Product Change Notification

PCN Number : PCN102

Product Category : Capacitors (Arc Suppression/Snubber Networks) - Design Change

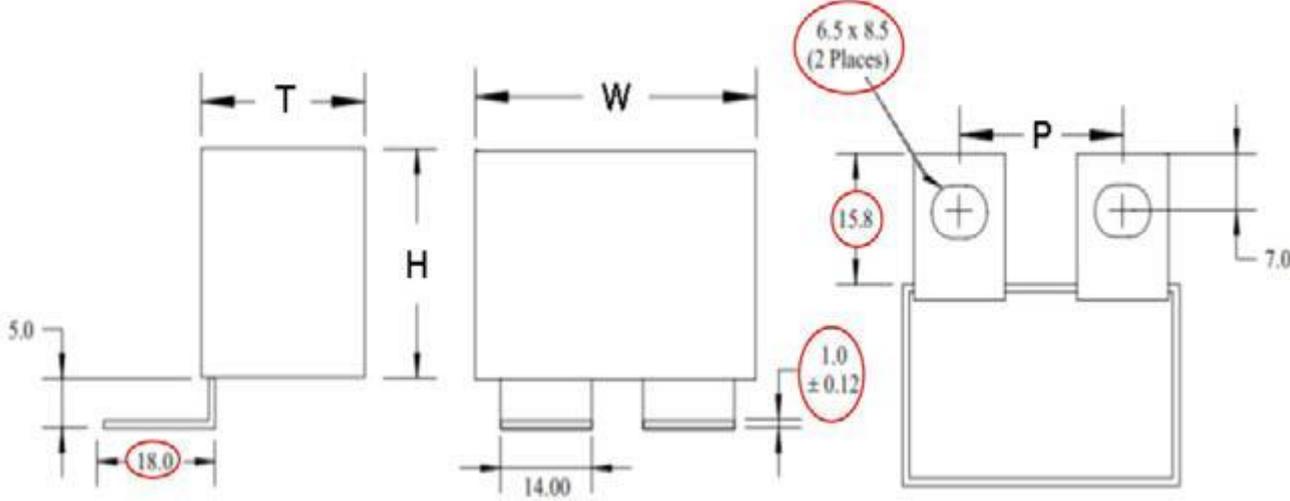
Reason For Change : Manufacturer made a slight change in size of the terminal for APB-Series.

Change to Form Fit Function : Changes occurred in Form and Fit and no change in Function

Before Change:

After Change:
